COUNCIL AGENDA: 12-5-06
ITEM: 11.4

SUBJECT: PDC06-062. PLANNED DEVELOPMENT REZONING FROM R-1-5 RESIDENCE ZONING DISTRICT TO THE A(PD) PLANNED DEVELOPMENT ZONING DISTRICT TO ALLOW UP TO 19 NEW SINGLE-FAMILY DETACHED ATTACHED RESIDENTIAL UNITS AND ONE EXISTING SINGLE-FAMILY RESIDENCE ON A 1.83 GROSS ACRE SITE, LOCATED ON THE TERMINUS OF DUCKETT WAY, APPROXIMATELY 420 FEET EAST OF SOUTH DE ANZA BOULEVARD (1566 DUCKETT WAY).

STAFF REPORT

File Number
PDC06-062

ALTERNATIVE SITE PLAN THAT MEETS 8.0 DU/AC

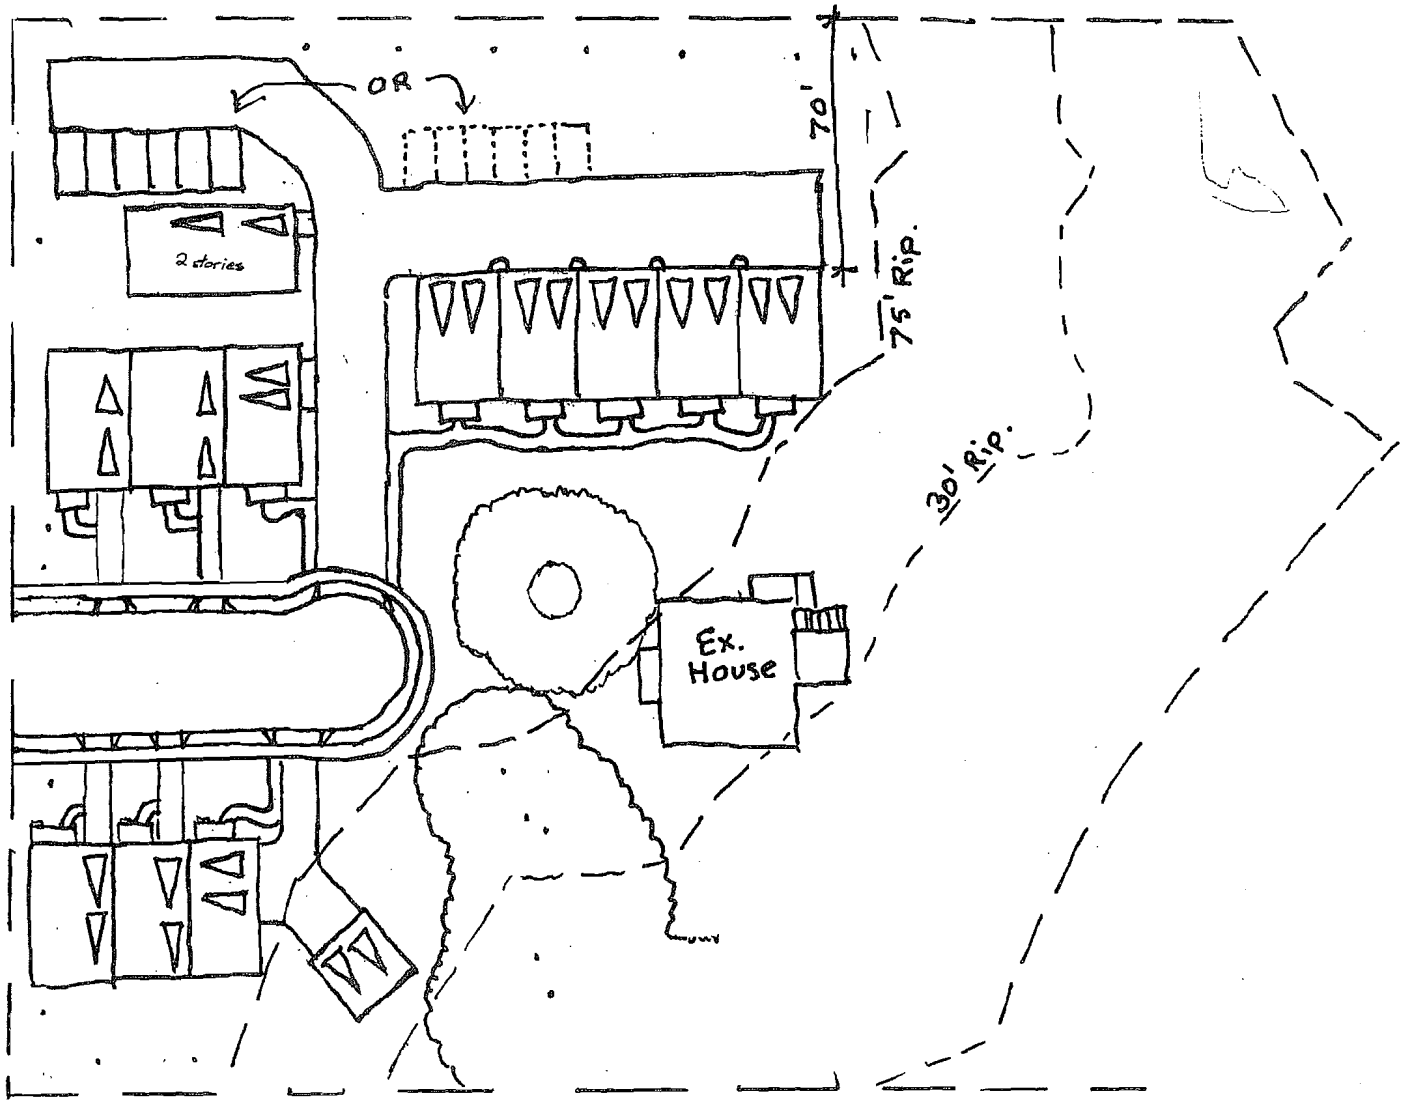
Staff then presented a site plan which included 12 attached single-family homes and retained the existing California Register eligible historic home. The site plan was presented for visualization purposes so that the audience and Commission could have an example of how the recommendations of the Riparian Corridor Policy and Residential Guidelines could be easily met on the site. The site plan, with 13 total units, also demonstrated that the current General Plan designation promotes development with a density that would meet all the City goals and policies. The site plan was designed to illustrate the design comments that were articulated in staff's initial comment letter to the applicant.

The applicant, Barry Swenson, was represented by Erik Schoennauer. Mr. Schoennauer stated that he was dismayed that Staff had a site plan, which was never presented to him prior to the hearing. In addition, he stated that Staff has never provided him any comments about the issues that were presented. Mr. Schoennauer asked the Planning Commission to look at the bigger picture of the project, rather than focus on the details that the Staff's Report indicated. He commented that the project had three main objectives: 1) riparian habitat preservation, 2) mature tree preservation, and 3) preservation of the existing historic house. Mr. Schoennauer also provided two lists detailing several projects that the City has approved that either 1) did not provide a 100 foot setback from riparian areas or 2) did not provide a 2:1 height to setback ratio for proposed three-story structures adjacent to existing single-family rear yards. He also indicated that Discretionary Alternate Use Policies of the General Plan were applied to some of those listed examples. He also claimed that the City has not approved any projects which have provided a 100 foot setback from a riparian area. Mr. Schoennauer indicated that he wanted the subject project to be fairly evaluated, given that the examples he provided illustrated that past projects had been approved that did not meet all City policies.

Staff acknowledged that they did not provide the alternate site plan to the applicant prior to the night's hearing. The alternate site plan was for illustrative purposes only. Again, Staff was not recommending approval of this alternative but rather using this as an exhibit for the Planning Commission to illustrate the specific written comments given to and/or discussed with the applicant early in the review process. Staff does not usually redesign projects for applicants, but rather provides feedback to design professionals regarding an application's conformance to ordinances and polices.
